PROJECT Turkevi Center
LOCATION Multi Firs
 821 FIRST AVENUE
 NEW YORK, NY
ARCHITECT PERKINS EASTMAN
 115 5th AVENUE, NEW YORK NY
CONTRACTOR TISHMAN CONSTRUCTION
 100 PARK AVENUE, NEW YORK NY

TITLE: Auditorium
ITEM NO.: 11, 11.01, 11.02, 11.03, 11.04, 11.05, 11.07, 11.08, 11.09, 11.10, 11.11
DESC.: PLAN
DESC.: AUDITORIUM SB1-24, VESTIBULE SB1-20 & SB1-17, WAITING ROOM SB1-22
By: PD **Scale:** As Noted **Job No.:** **Dwg. No.:** 11-01
Status: IN SUBMITTAL REVIEW **Date:** 2019-01-21

08
ELEVATION
SCALE: 1/2" = 1'-0"
Arch Ref.: 2/A-603.00

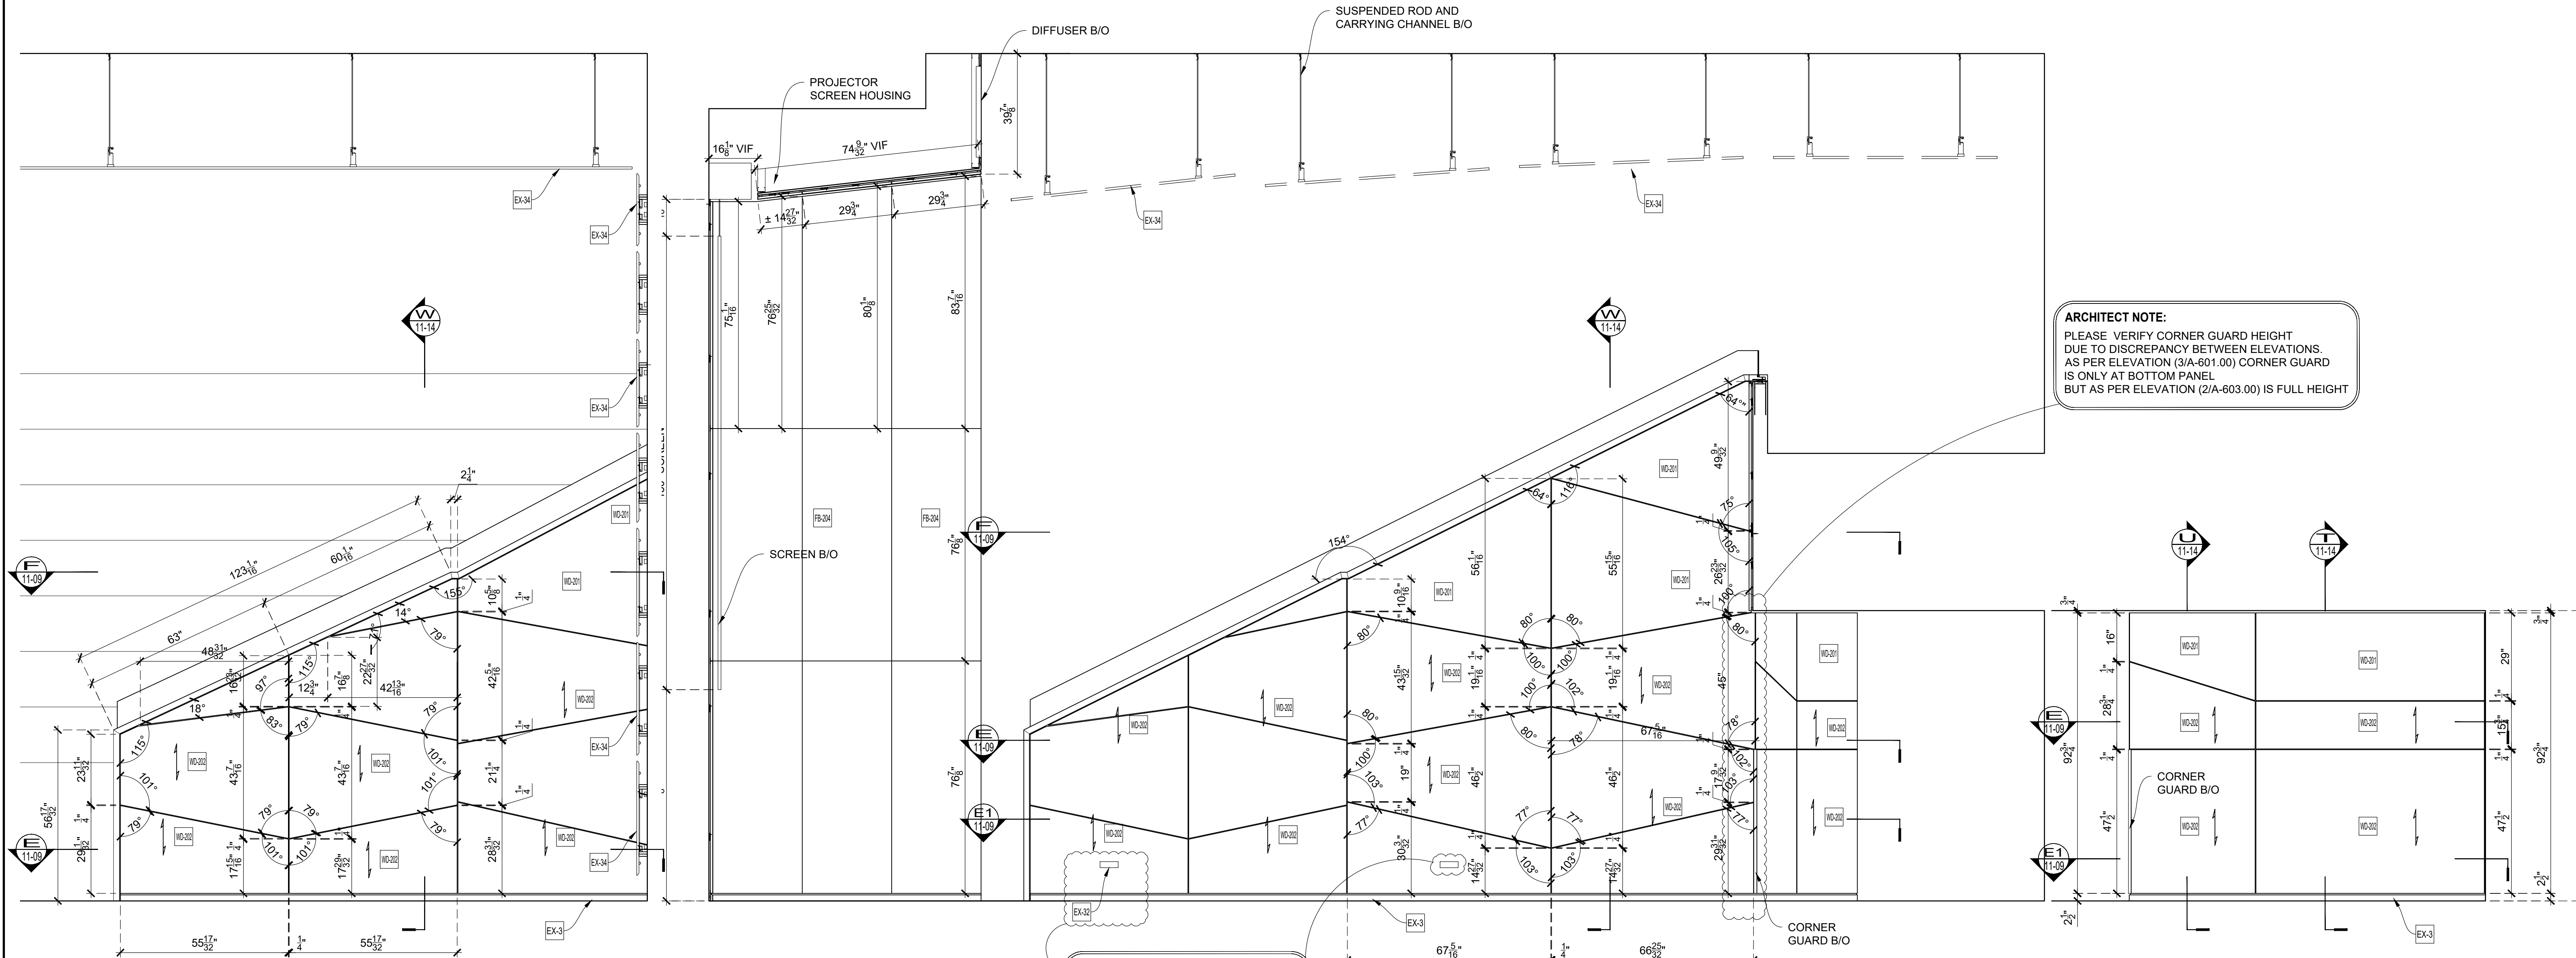
ARCHITECT NOTE:
SPECIFY LOCATION OF LIGHT FIXTURES

ARCHITECT NOTE:
PLEASE VERIFY CORNER GUARD HEIGHT
DUE TO DISCREPANCY BETWEEN ELEVATIONS.
AS PER ELEVATION (3/A-601.00) CORNER GUARD
IS ONLY AT BOTTOM PANEL
BUT AS PER ELEVATION (2/A-603.00) IS FULL HEIGHT

ELEVATION 11 SCALE: 1/2" = 1'-0" Archt Ref.: NONE
ELEVATION 12 SCALE: 1/2" = 1'-0" Archt Ref.: 2/A-604.00
ELEVATION 13 SCALE: 1/2" = 1'-0" Archt Ref.: NONE

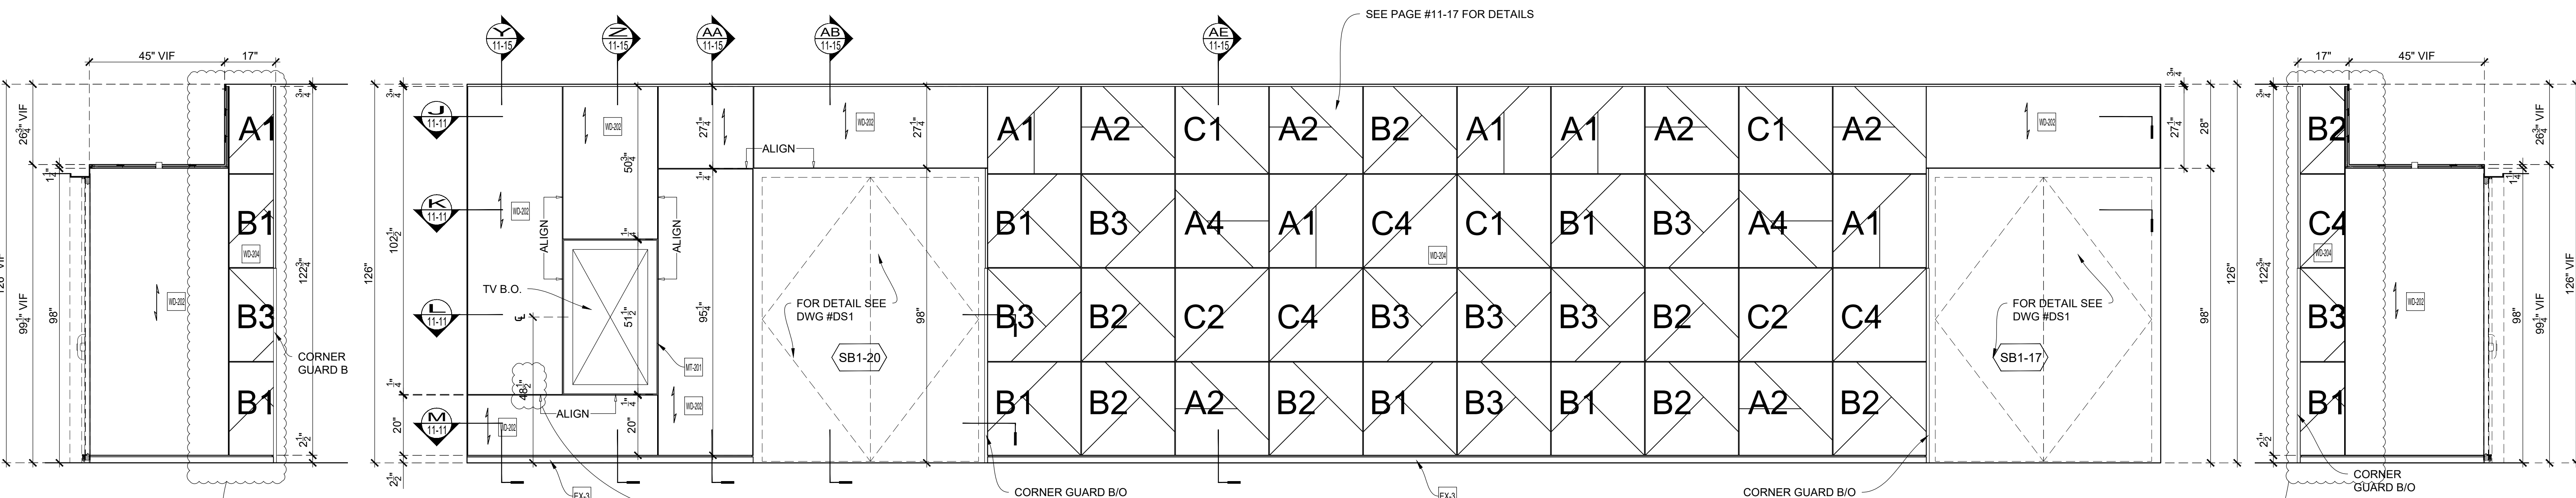
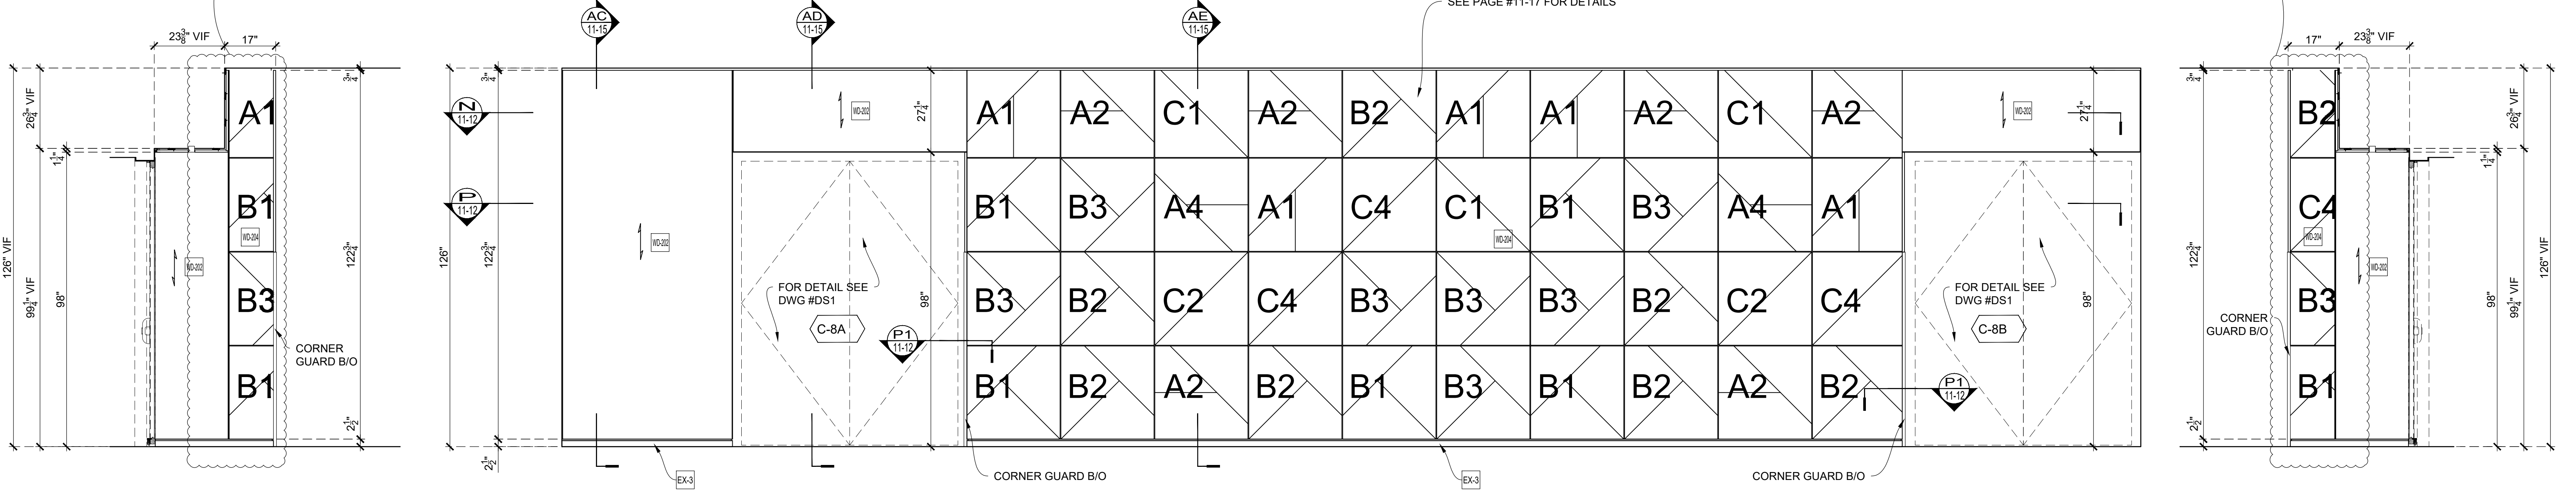
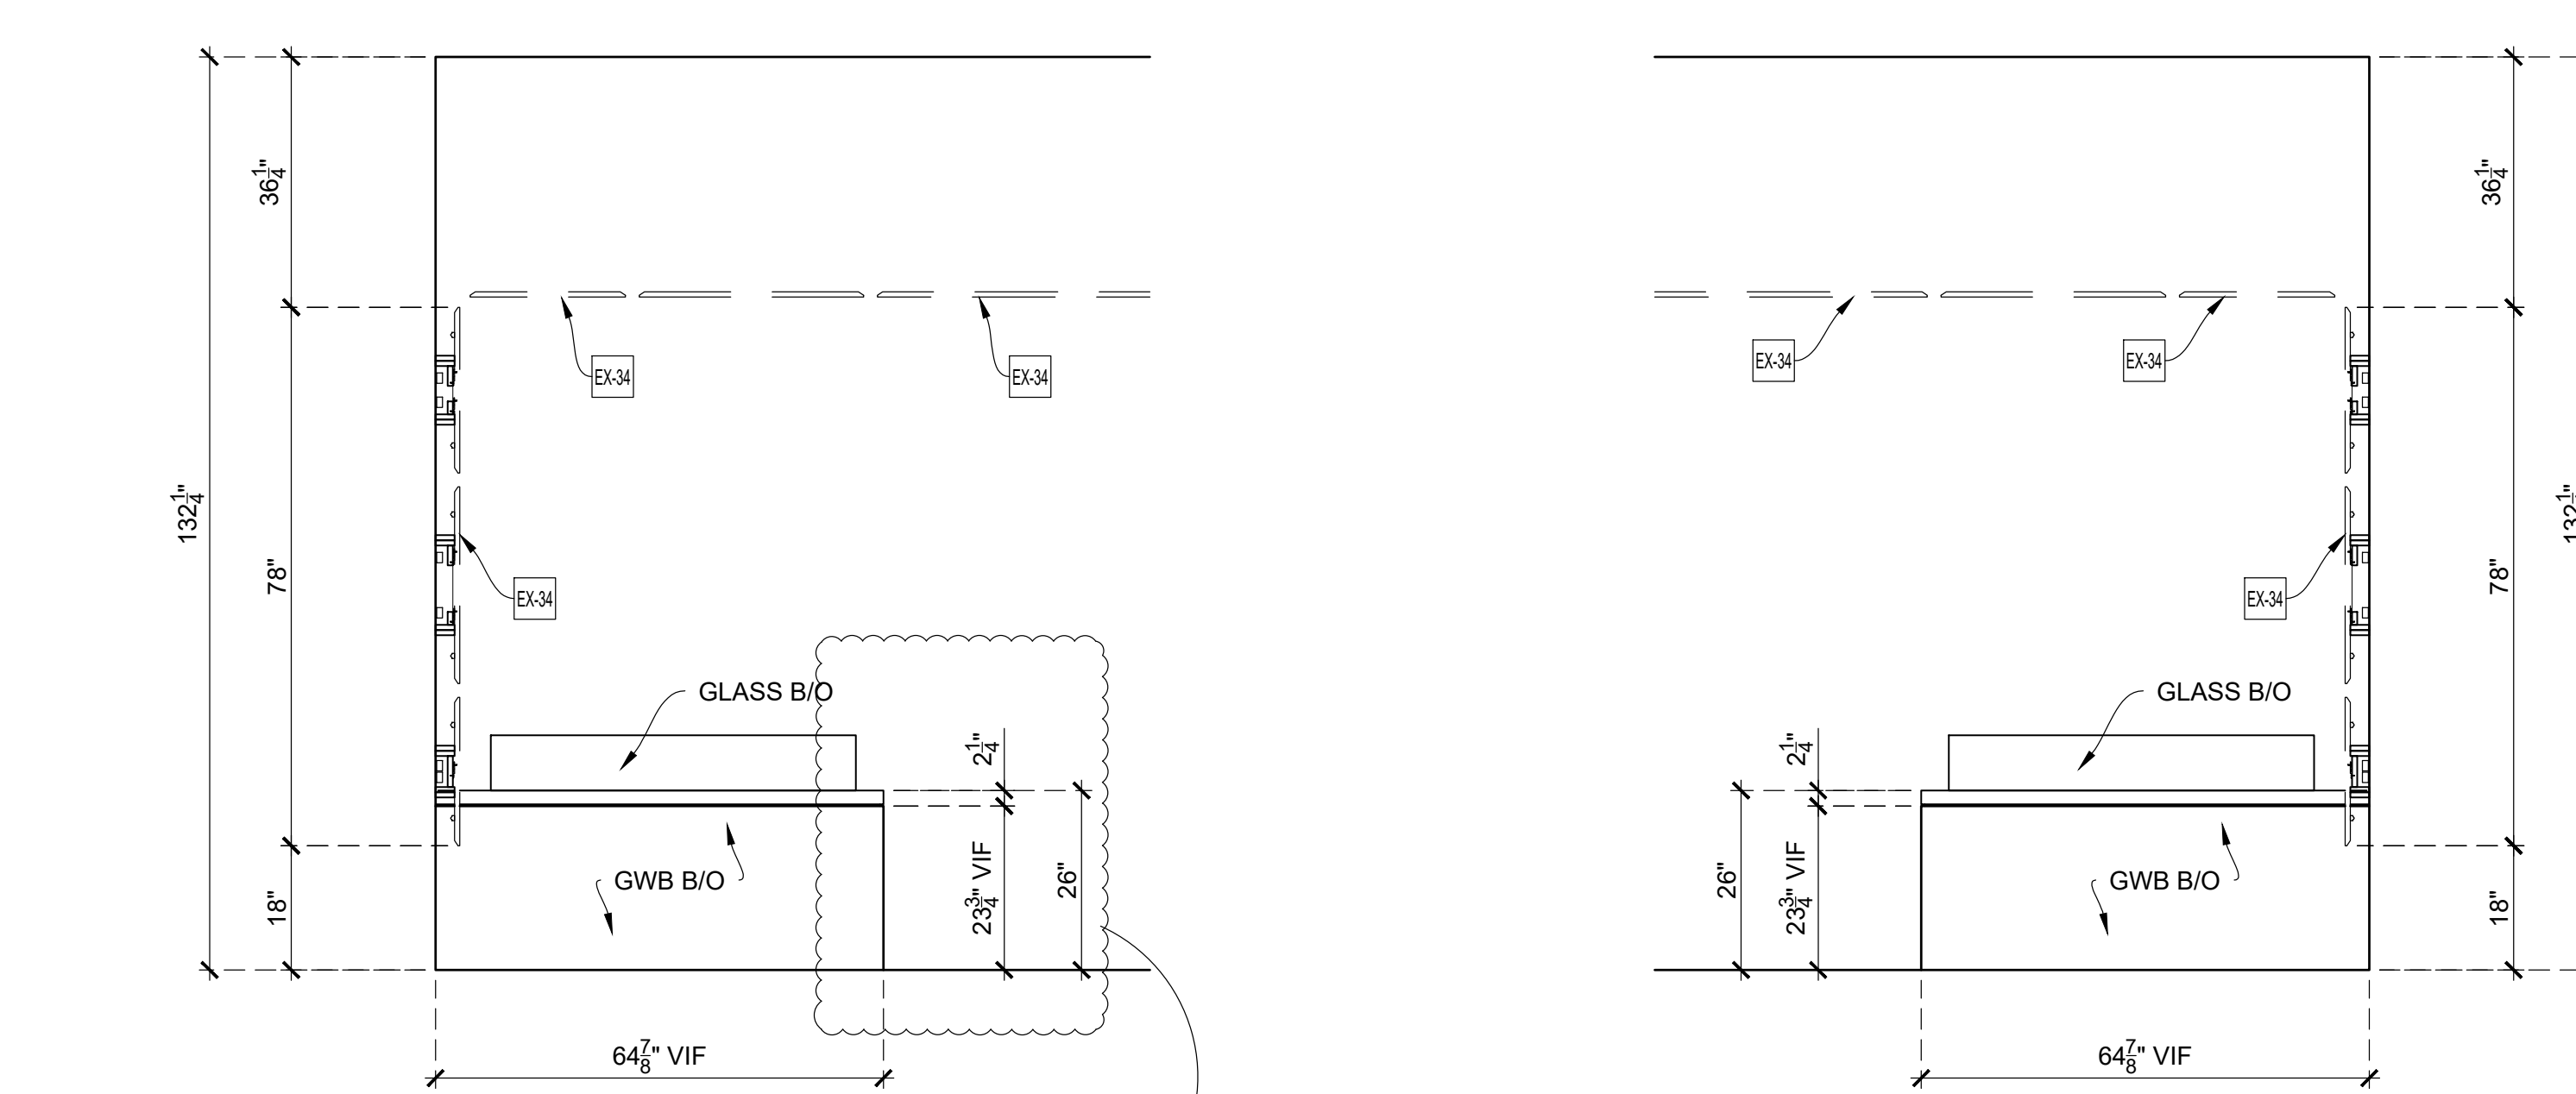
ARCHITECT NOTE: PLEASE VERIFY DIMENSION

ARCHITECT NOTE: PLEASE VERIFY LAYOUT @ THESE WALLS

ARCHITECT NOTE: PLEASE VERIFY LAYOUT @ THESE WALLS

ARCHITECT NOTE: PLEASE VERIFY CONDITION. THERE ARE DISCREPANCY BETWEEN ELEVATION (2/A603.00) AND VERTICAL SECTION (1/A-653.00)
